# Mallard Pass

### Environmental Statement Volume 2

### Appendix 6.6 - LVIA Viewpoint Correspondence

**Land At Mallard Pass Essendine – Landscape & Visual Impact Assessment**

**DWG. NO. 7863\_100**

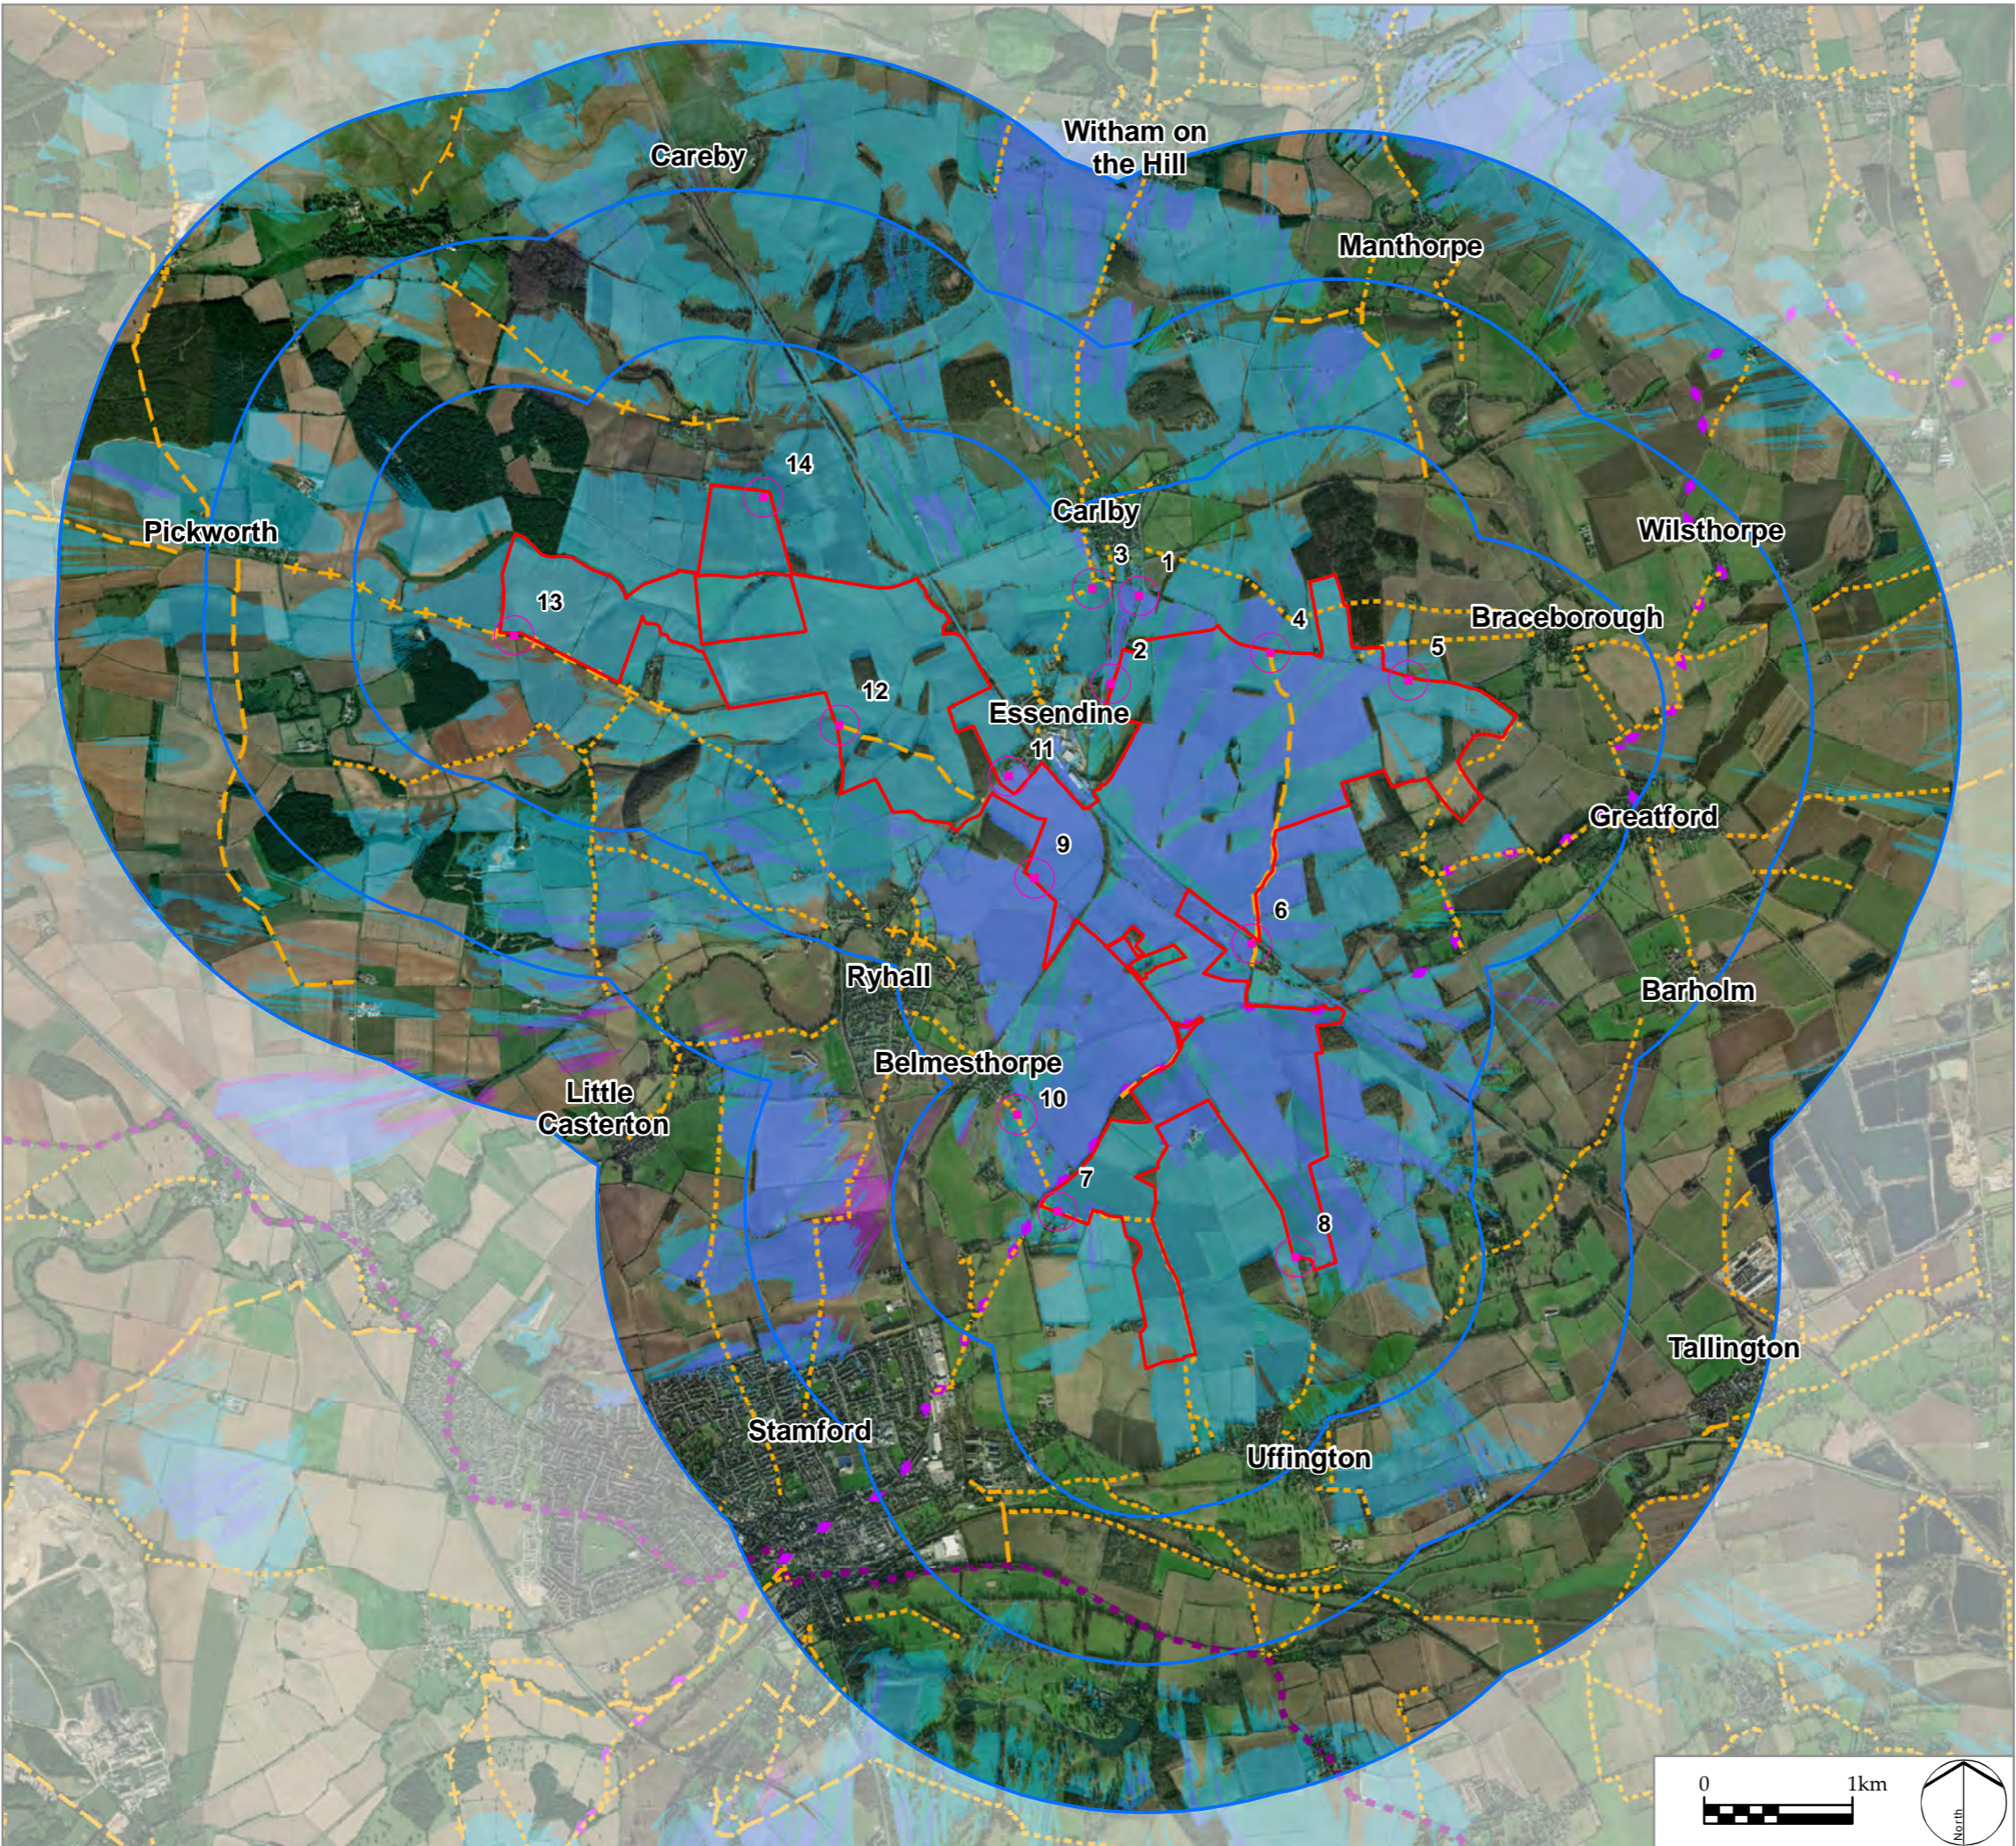
The preliminary ZTV study shown on the enclosed plan (**DWG 7863 \_100**) has been modelled on solar panel heights and other built form infrastructure of 3.5m (maximum), located within parcels of land within the Site which are identified for potential solar development, with the substation area adjacent to the existing National Grid Substation modelled at a height of 13m (see **Illustrative Layout DWG 7863\_000**). The baseline study, site visits and development of the design (including appreciation of landscape and visual sensitivities) have identified areas within the Site to remain undeveloped in order to minimise potential landscape and visual impacts and provide multifunctional mitigation and benefits.

The Site and location of the proposed viewpoints are shown on the ZTV and Viewpoint Location Plan (DWG 7863 \_100). In addition to the 14 representative viewpoints, illustrative views will be identified during the assessment process to illustrate and describe particular points made within the assessment. These may include locations outside the study area to illustrate the nature of visibility, if necessary. Additionally, we propose to produce rendered photomontages for years 1 and 15 of the Proposed Development from Viewpoints 1, 2, 3, 10 and 11 to demonstrate the views from a range of receptor points where the Proposed Development may be seen to understand the potential impacts.

DRAWING TITLE  
Figure111: Amenity and Recreation

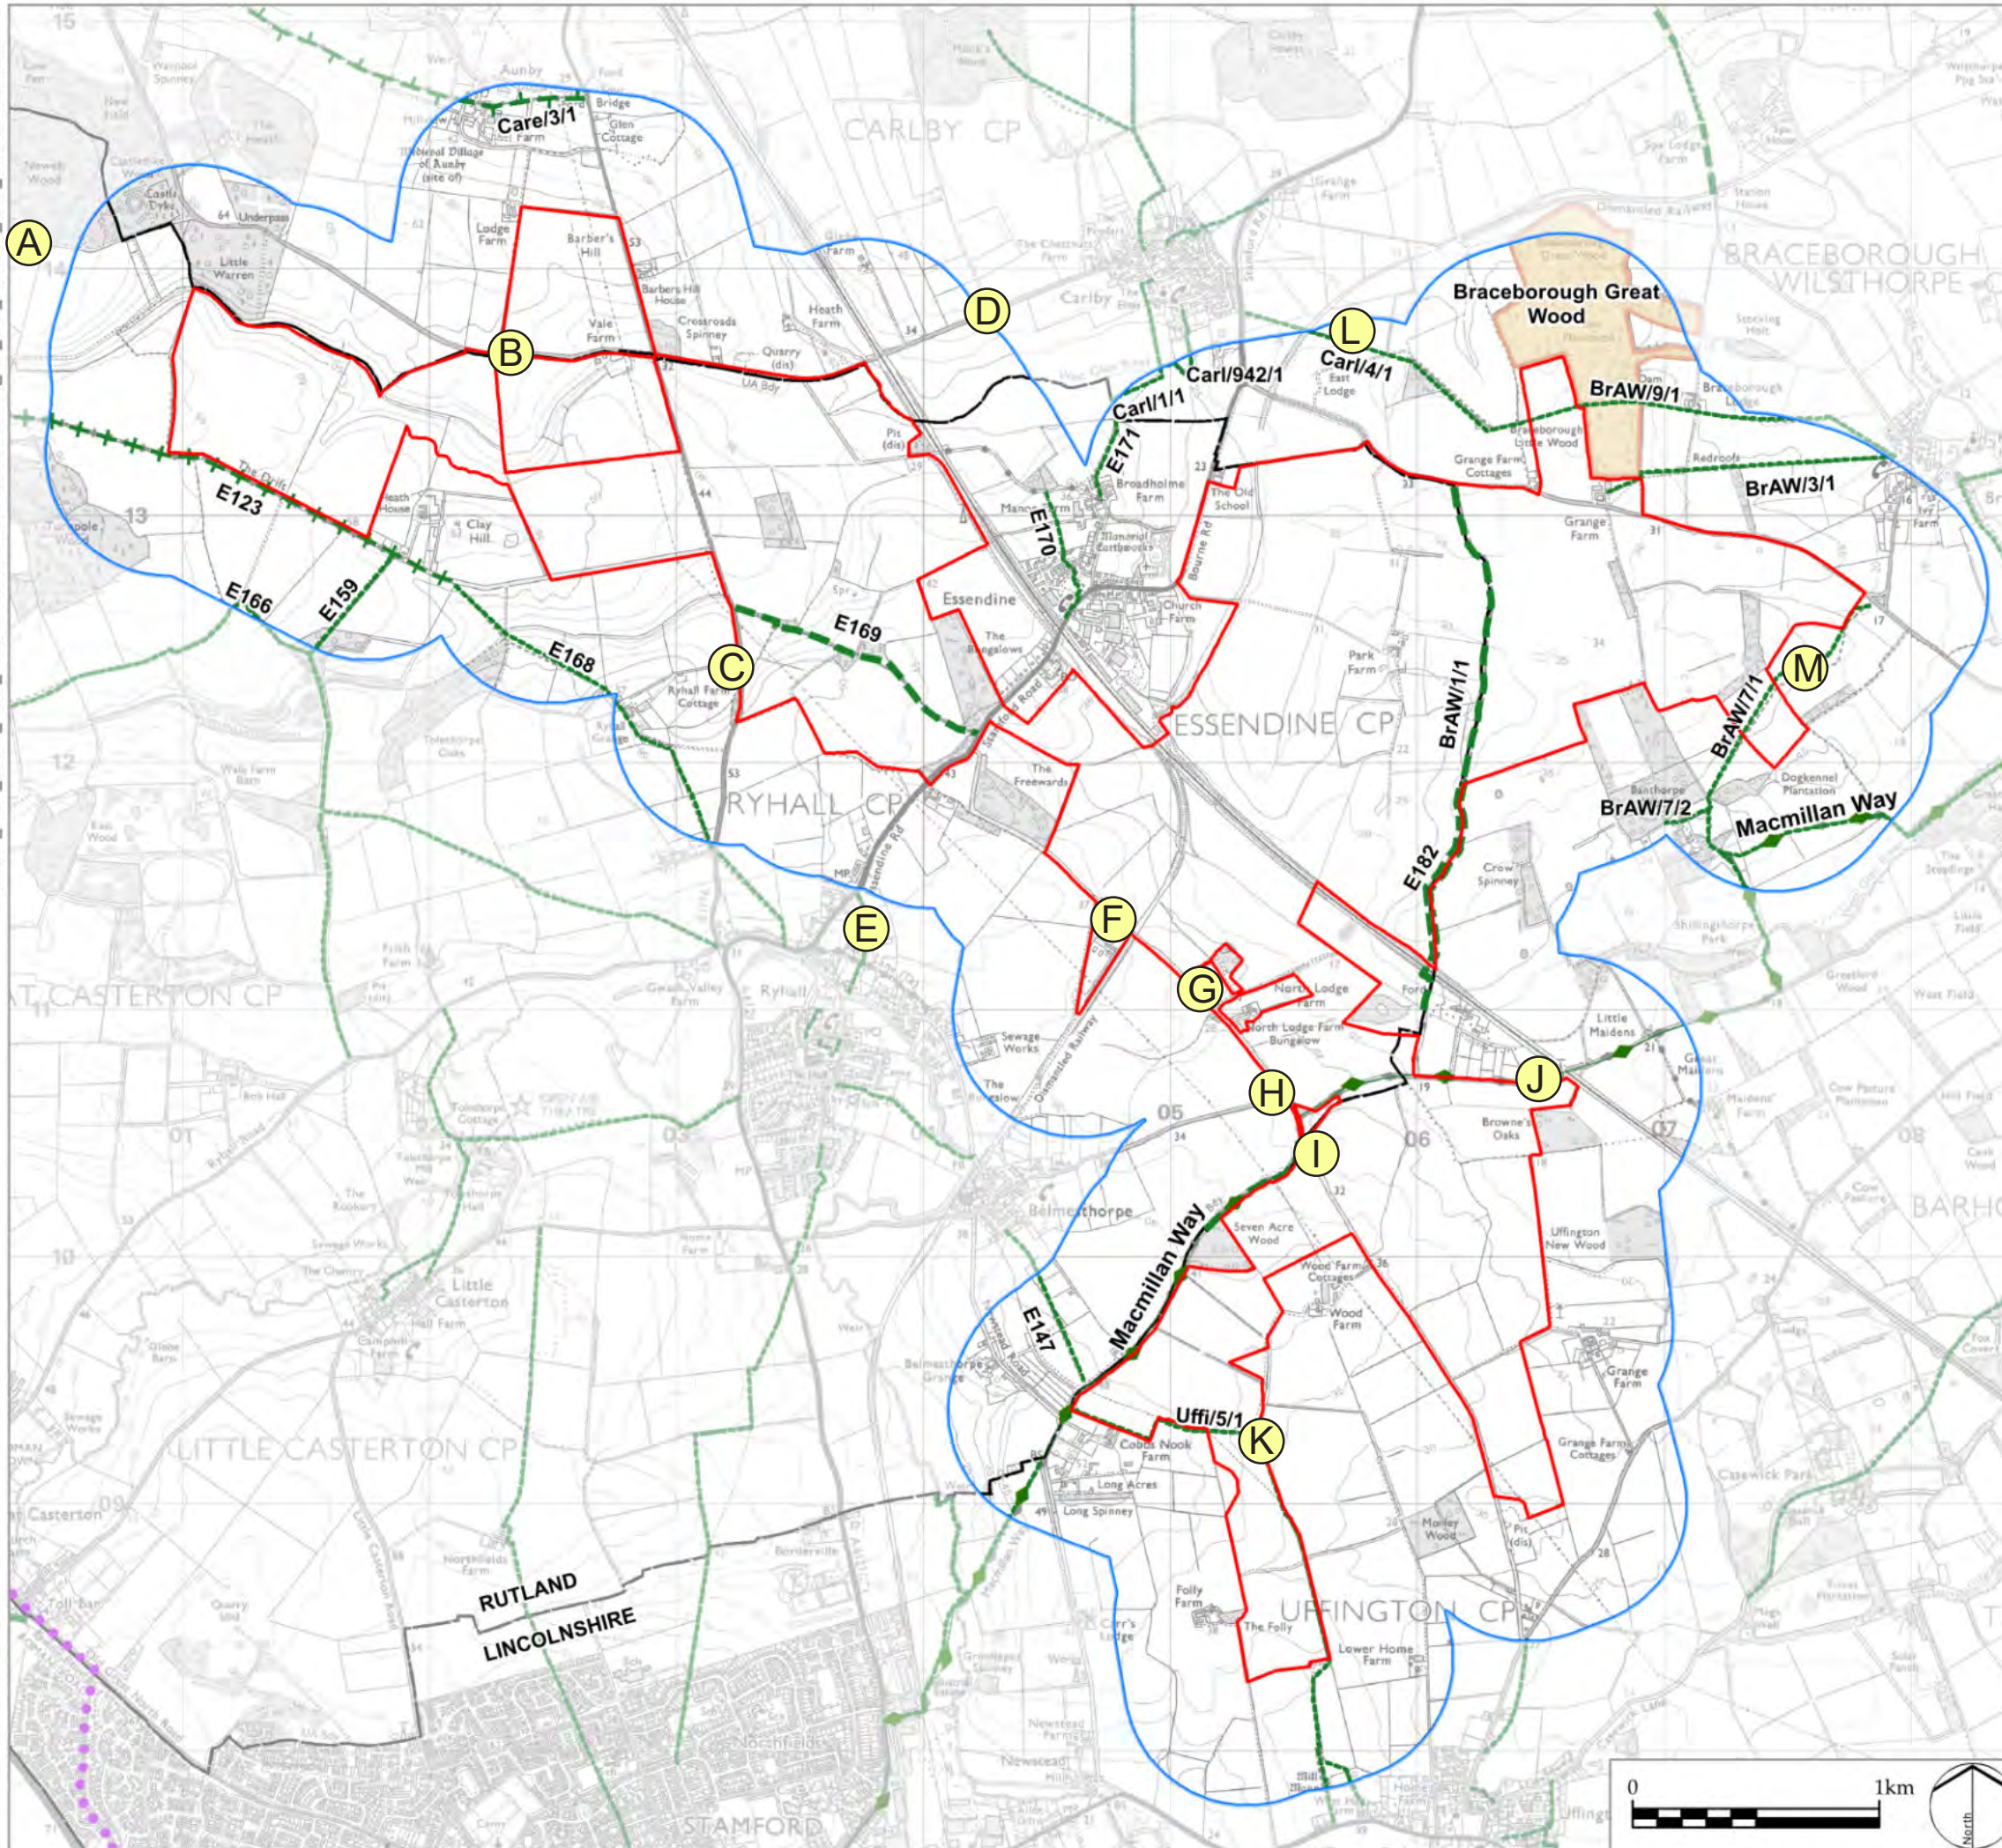
We walked the Mallard Pass Solar site and surrounding area and visited all the viewpoints currently proposed by LDA. The proposed viewpoints were identified on the draft drawing: *7863\_100 Zone of Theoretical Visibility (ZTV) Study Including Woodlands and Settlements – Proposed Viewpoints* (Dec 2021) that was appended to the LDA letter dated 10 January 2022. However, following the discussion on 6<sup>th</sup> April 2022, it was highlighted that through further fieldwork and consultation some additional viewpoints would be proposed by LDA. These were highlighted within the discussion and these additional potential locations were also visited on site by AAH.

The following comments are in regards to visibility of the site from specific receptors and viewpoints, and the plan attached to this memo should be referred to for these target notes, which we would suggest are discussed at a further workshop prior to finalising. All photography should provide the most advantageous views of the site and proposed development:

As stated, at this stage we do not have details on the location and appearance/extent of taller/larger elements that for part of the development which would likely have visual impacts that would require additional viewpoints beyond those initially identified.
